**RE: 1836 COVE POINT ROAD
Annapolis MD, 21401
Variance Application**

CONFIRMATION OF PRE-FILE

PRE-FILE #: 2025-0009-P
DATE: 02/06/2025
OPZ STAFF: Jennifer Lechner
Kelly Krinetz
I&P STAFF: Habtamu Zeleke

SITE LOCATION: 1836 Cove Point Road, Annapolis

VARIANCE PLAN
1836 COVE POINT ROAD
1836 COVE POINT ROAD, ANNAPOLIS, MD 21401
TAX ACCT. NO. 02-000-02456700
TAX MAP 045F GRID 0002 PARCEL 0540 DISTRICT 2ND
ANNE ARUNDEL COUNTY, MARYLAND

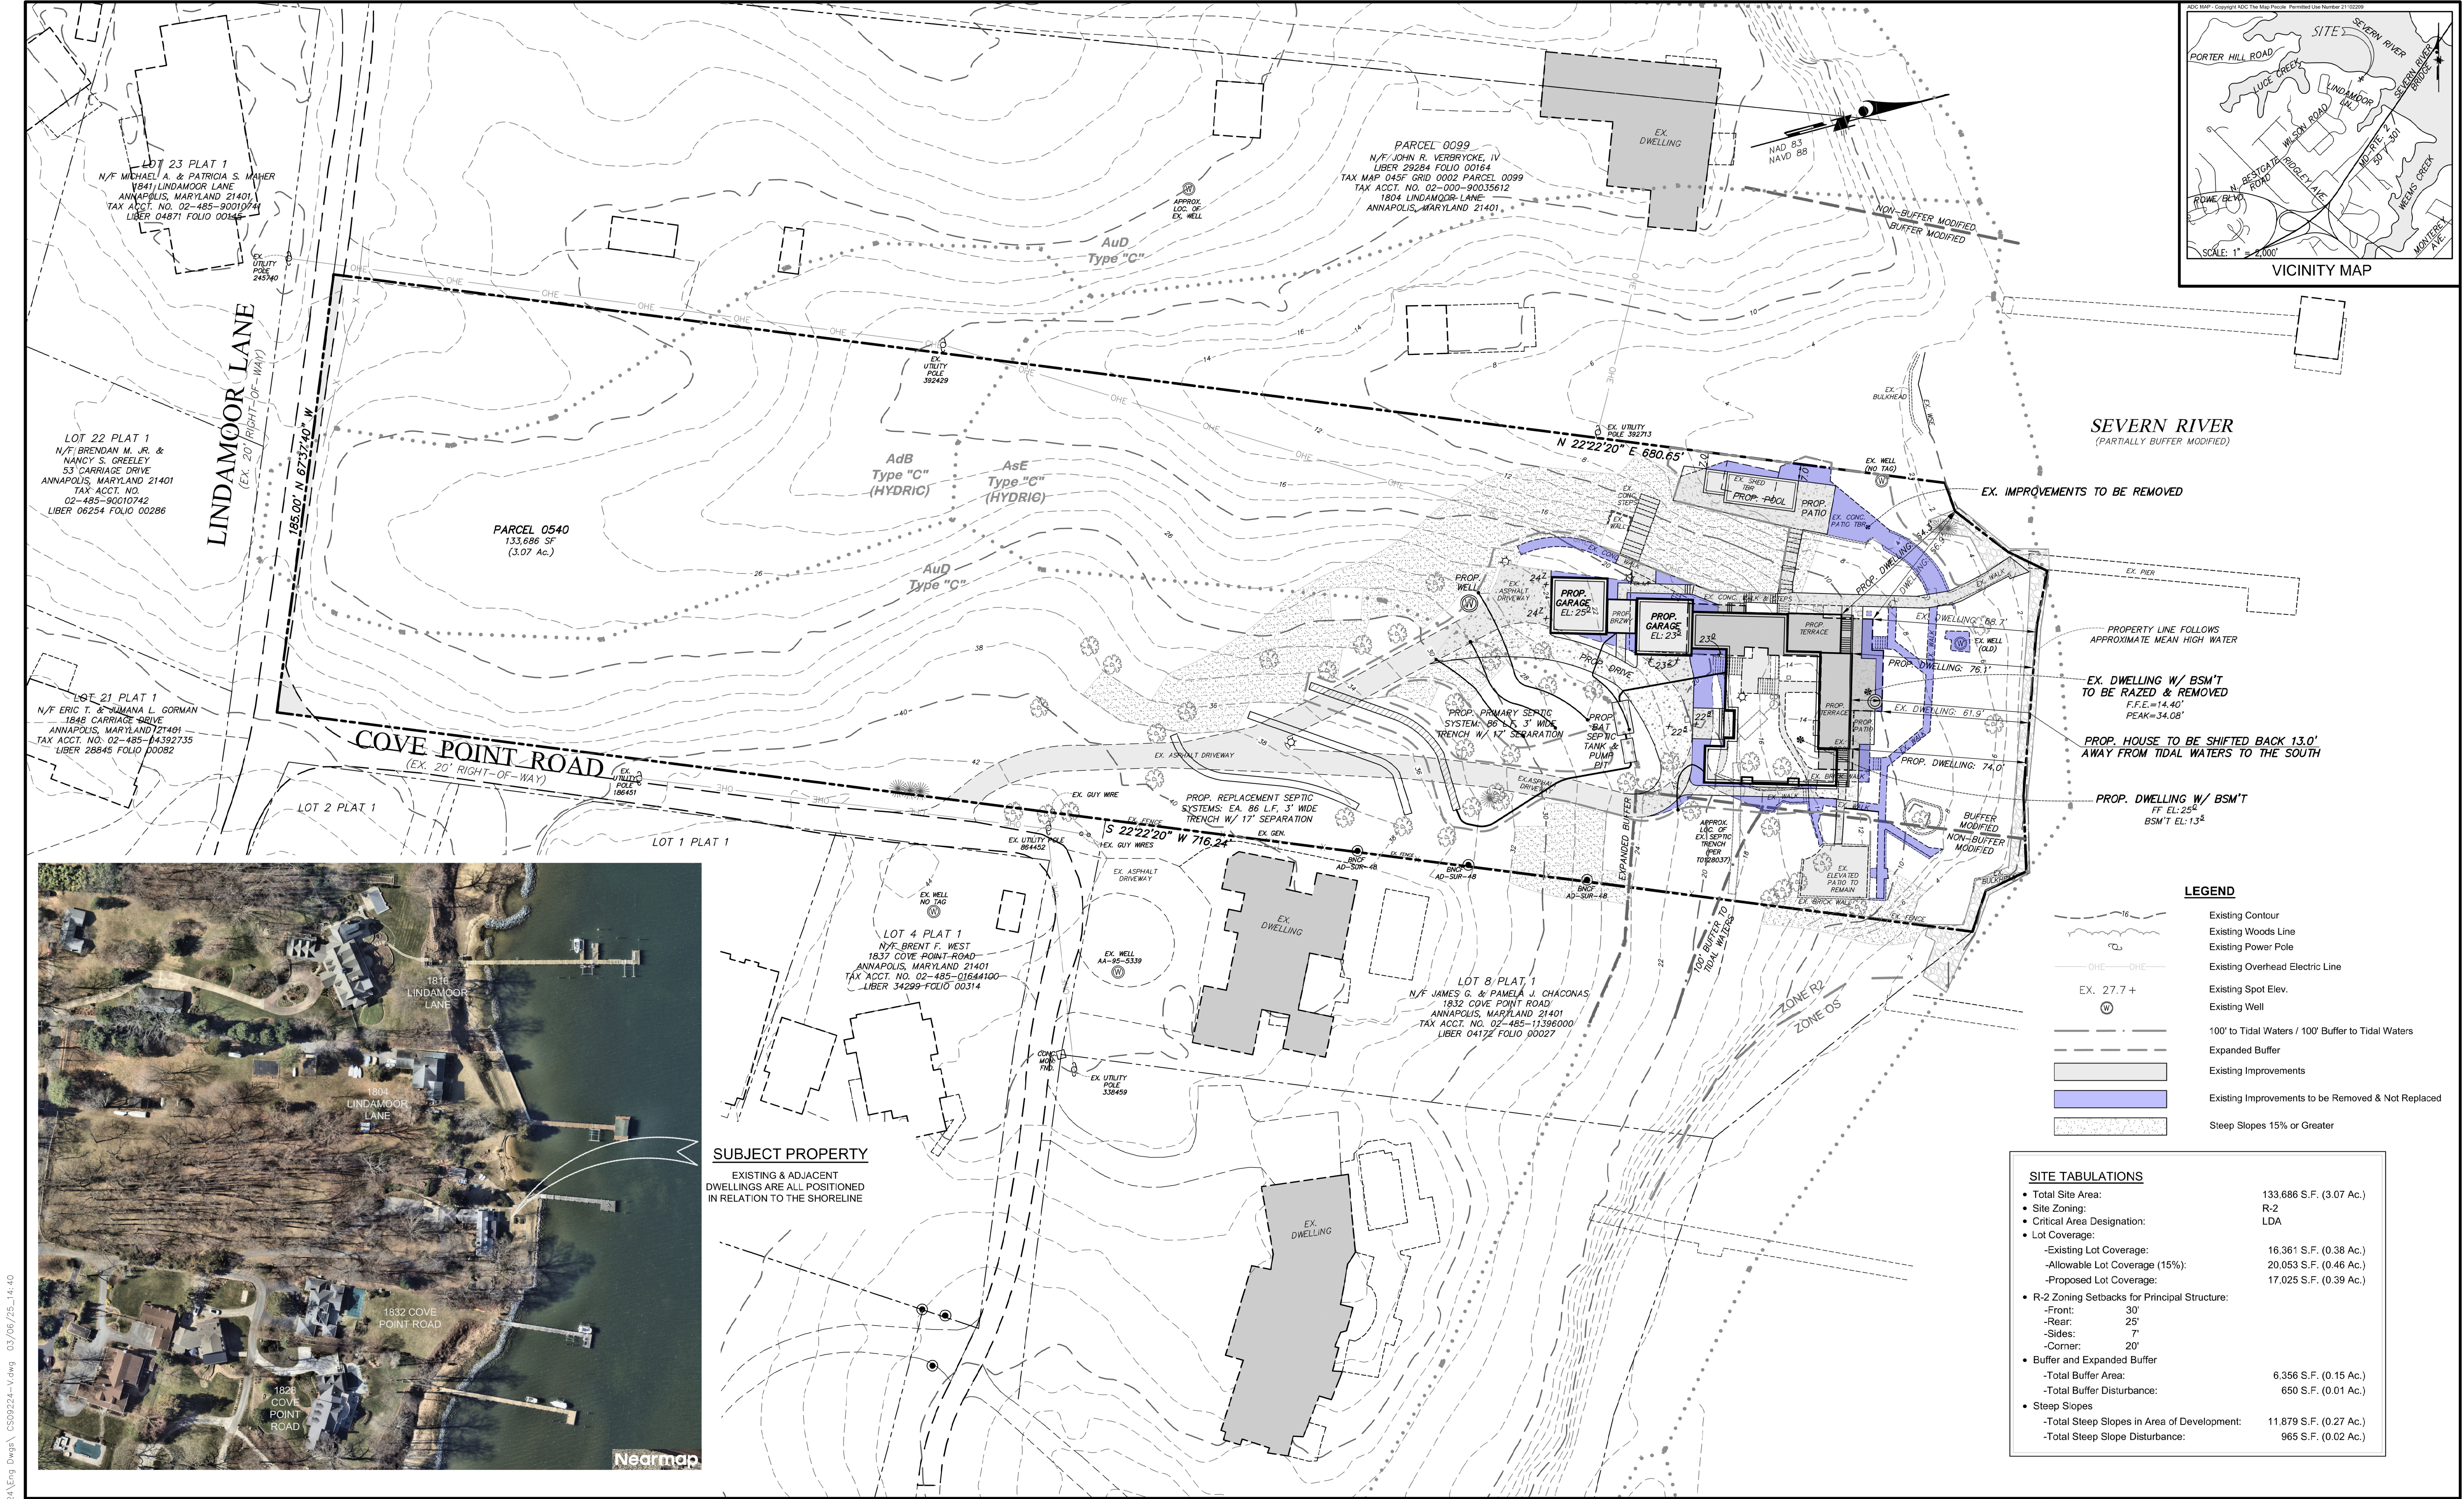
The Administrative Site Plan must specify the setbacks, dimensions, height, and number of stories of all structures. Providing the floor plans and/or architectural elevations (front, side and rear) is strongly recommended in order to assist in the evaluation of any requested variance.

The site plan does not include the location of the proposed septic area. The driving force to the proposed location of the dwelling is the preservation of the existing woodland so the location of the septic area must be considered. Given the lot size, existing vegetation and the movement of the home back from the existing location, this Office has no objection to the generally in line request.

This Office has no objection to the location of the pool provided the applicant can demonstrate that there will be no additional slope disturbance related to the location. The proposed walkway expansion cannot be supported if it involves additional slope disturbance.

1. It is unclear how Stormwater management will be addressed for the raze and rebuild of the existing house.
2. Please ensure that the minimum well and septic setbacks to proposed SWM practices are achieved.
3. Per Code 17-6-404, disturbance within the 25' steep slope buffer (SSB) is prohibited.
4. All stormwater conveyance systems shall be designed so that no building or habitable structure, either proposed

or existing, is flooded or has water impounded against it during the 100-year storm event.

5. Per 6.1.4 (G) of the County Stormwater Practices and Procedures manual, SWM facilities shall not be located in areas that are off-limits to development, e.g., natural resource areas and their steep slopes and buffers.

6. Microscale stormwater facility(ies) design should incorporate safe conveyance for overflow discharges from 2, 10, 100-yr 24-hr storm events; plans should show overland relief paths for these storm events and ensure that no structures, or properties are negatively impacted or have water impounded against during these storm events.

7. Ensure the proposed improvement including runoff, seepage, and slope saturation does not adversely impact the integrity of the slope and potential impact of slope failure.

8. A soil boring is required per practice. The suitability and siting of proposed SWM practices should be reviewed. Soil boring information including verification of the suitability of in-situ soils for infiltration shall be submitted. Describe the site's hydrologic, and topographic characteristics and provide a recommendation on the feasibility of various BMPs.

9. Based on the plan provided, it appears that the property will be served by a private septic and well.
10. The utility for the site will be reviewed during the grading permit.
